# LINTON PARISH COUNCIL

**RE: Consultant comments on behalf of Linton Parish council for S/2501/19/RM – Land to the North and South of Bartlow Road, Linton**

## Introduction

*Image 5a. South Site Section FF showing the effect on existing houses and overlooking from the upper terraces. The upper circle shows the raised upper level of houses.*

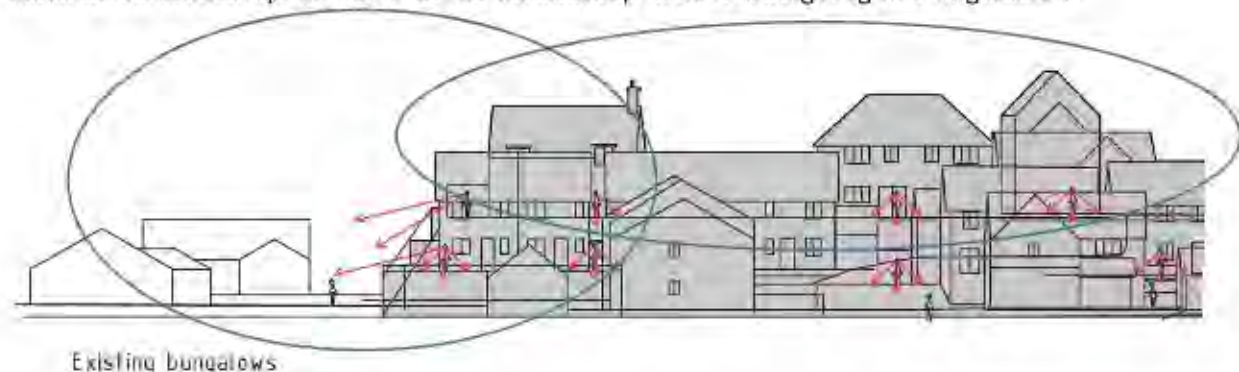
None of the Sections provided show the relationship to the existing neighbouring houses.

The terracing and building up the land profile results in a development that would dominate the existing houses, which are built into the slopes, and are predominately bungalows, as demonstrated in images 1-3 above.

*Image 5b. South Site Section FF continued, showing the relationship of upper terraces and the properties below, and the potential overlooking.*

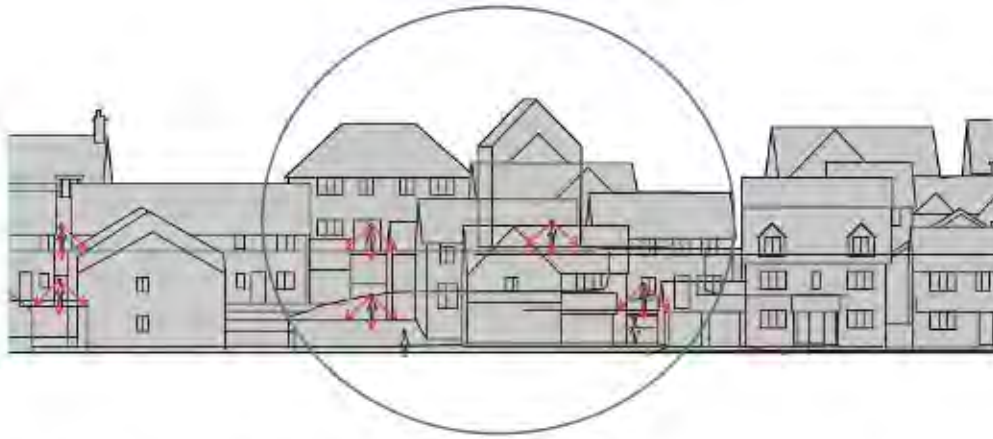
Whilst the differences in level are up to 8½ metres on the Southern Site, they are less on the Northern Site, but there are similar problems of dominance and overlooking from the higher terraces.

*Image 6b. North Site Section CC showing the houses raised above Bartlow Road and the Southern Site. The boundaries on the left indicate how much build-up there is to provide platforms above the natural ground level.*

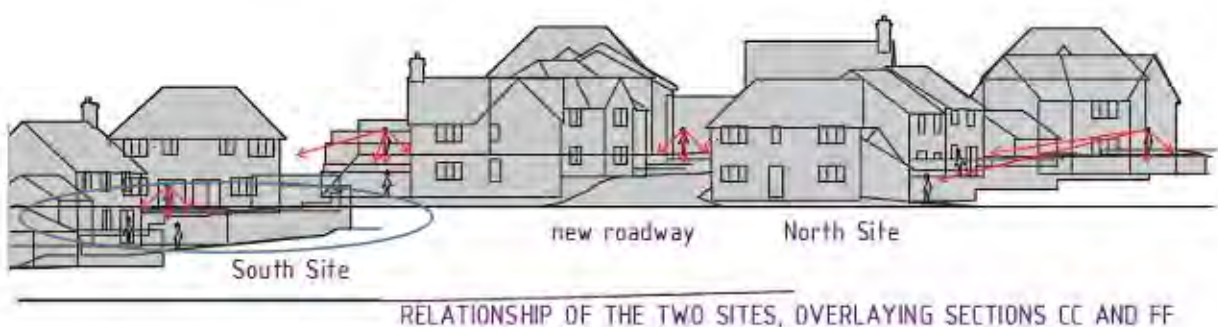
(The images above have layered the sections on submitted drawings 1552-104H, 105E, 1007A and 1008A, to show the depth of the development and the comparative heights).

*Image 14. Central bank of deep span houses.*

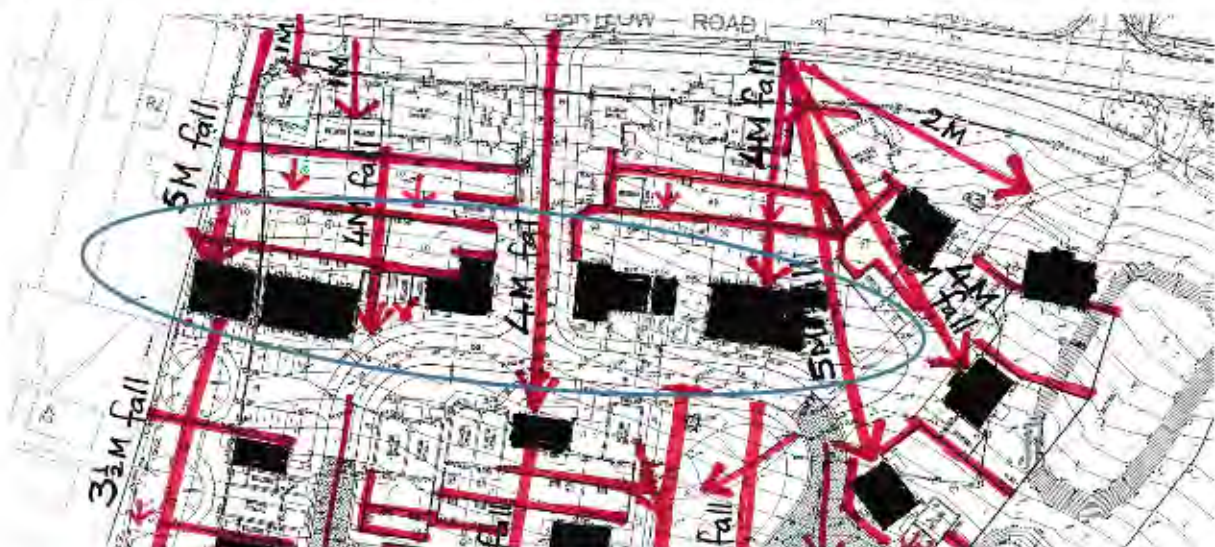
Nearly half the houses in the proposed scheme have excessive spans, most of them being 10 metres deep, which is double the depth of the houses characteristic of Linton. The excessive spans give very poor gable proportions compared to vernacular buildings (the roof looks too slack and the standard windows too small).

The gable is longer than the frontage, which makes the building look sliced and incomplete. It also makes the fenestration of the front and rear elevations look cramped and is contrary to the linear proportions of vernacular buildings in this locality (see above).

The terraces of deep-span houses create a block-like appearance in a band across the centre of the site, at odds with the generous spacing of existing houses in this part of the village and the rural character of the edge of the village. They are also cramped and leave insufficient space for the species-rich western boundary hedge to be retained and any replacement hedge to thrive.

*Images 15a – 15b. Typical FOG unit, comprising a flat above car parking, or a flat above a parking courtyard access.*

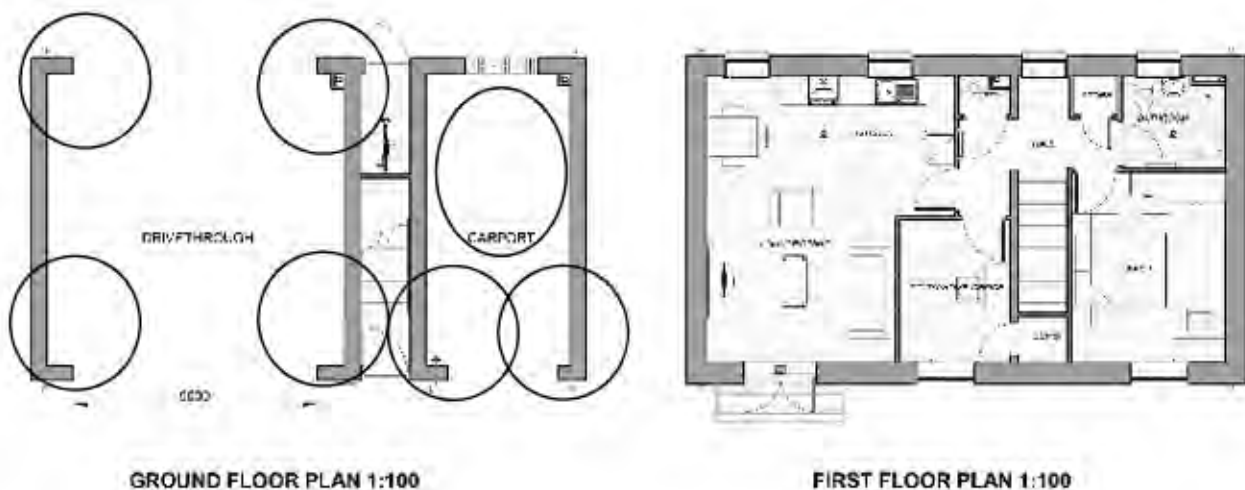
*Images 15c – 15d. Typical FOG plan, with poor street presence at ground floor and many potential hiding places. Together with the bars on the openings, they create an inhospitable and poor street presence.*

These FOG units are flats with very poor townscape appearance, dominated by vehicle provision. They are very urban in appearance and not typical of a rural village like Linton. They have top-heavy proportions, and at street level, where most people would experience them, the view would be dominated by cars, services, bins and barred openings. This is not high quality design as required by HQ/1.

*Images 16 a-c. Tower House showing proportions and dark un-fenestrated elevations.*

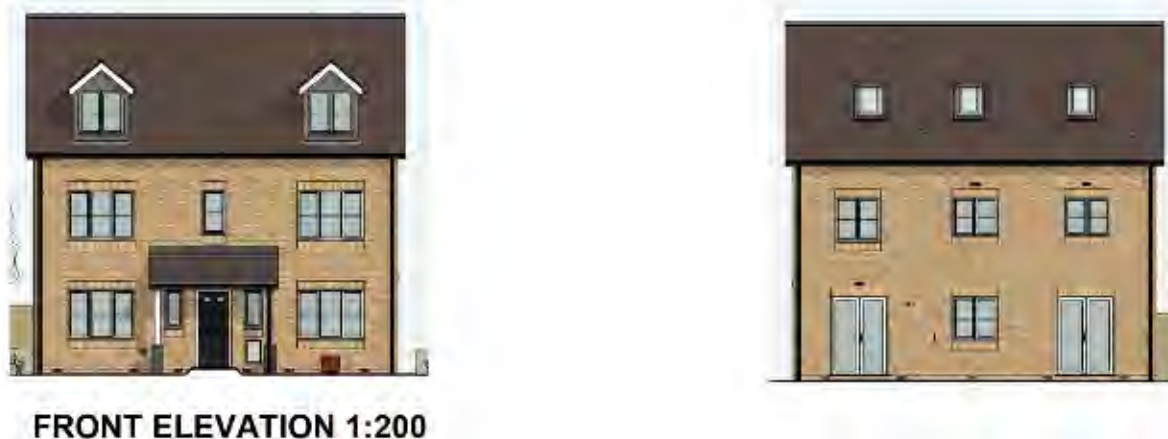
The Tower house is 3 storeys high, which would dominate the scale and heights of the surrounding houses of the locality, which are single storey and a modest two storey. The dominance is increased by the vertical proportions of the design. Whilst 'landmark tower' buildings are advocated in the District Design Guide, that document makes clear that this is for urban contexts, not for rural villages. The large 'landmark tower' is not typical of Linton, where landmark buildings are often modest and become a landmark because of the quality of the streetscape (Image 11b).

The proportions and alignments of openings on the prominent elevation facing the entrance road are unsettling (because of duality and a mix of balance and unbalance), and there is an unfriendly blank black elevation facing the neighbours, where it would tower above a narrow pathway, rather than the green idyllic context indicated on the drawing.

Image 22. An overlay of the Environment Agency flood map data over the proposed site layout.

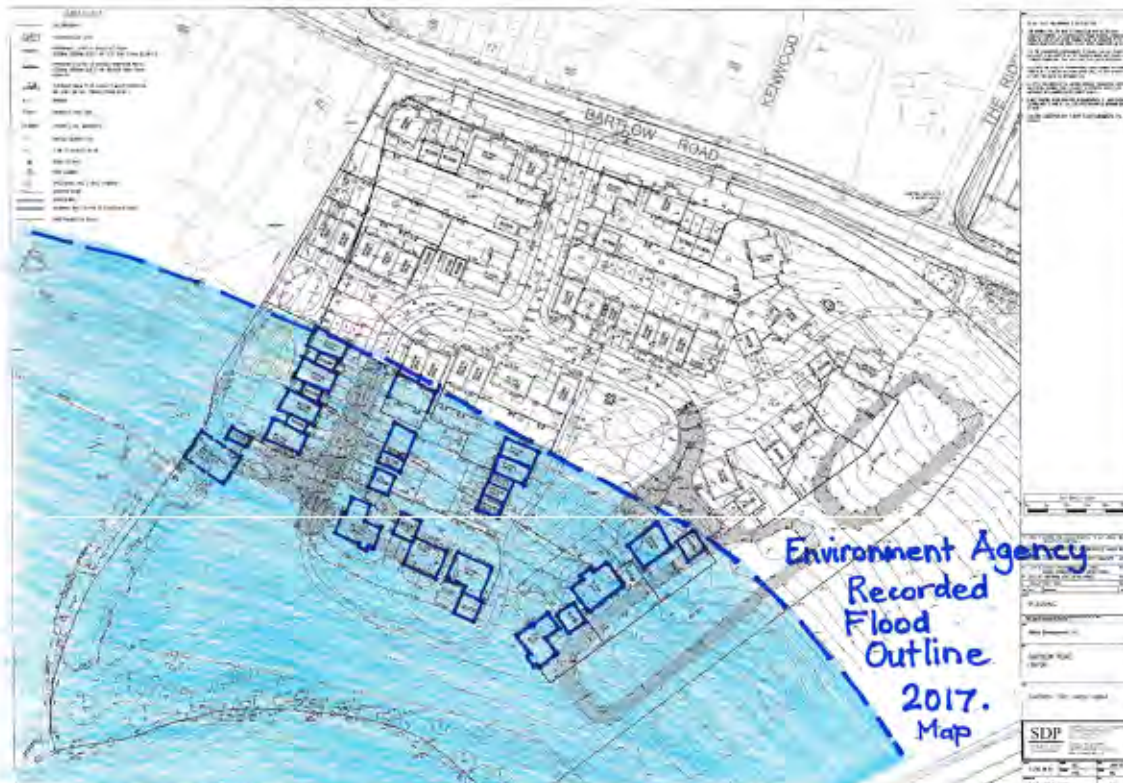
These show that a significant number of houses are within an area that has flooded within the last two generations, and is therefore likely to flood again, and to a greater extent than before due to Climate change.

The submitted site sections show that the houses on the lower part of the site are built up above the natural ground level, giving them greater prominence in the landscape and key views, and providing barriers that do not absorb water and are likely to increase flood risk elsewhere.
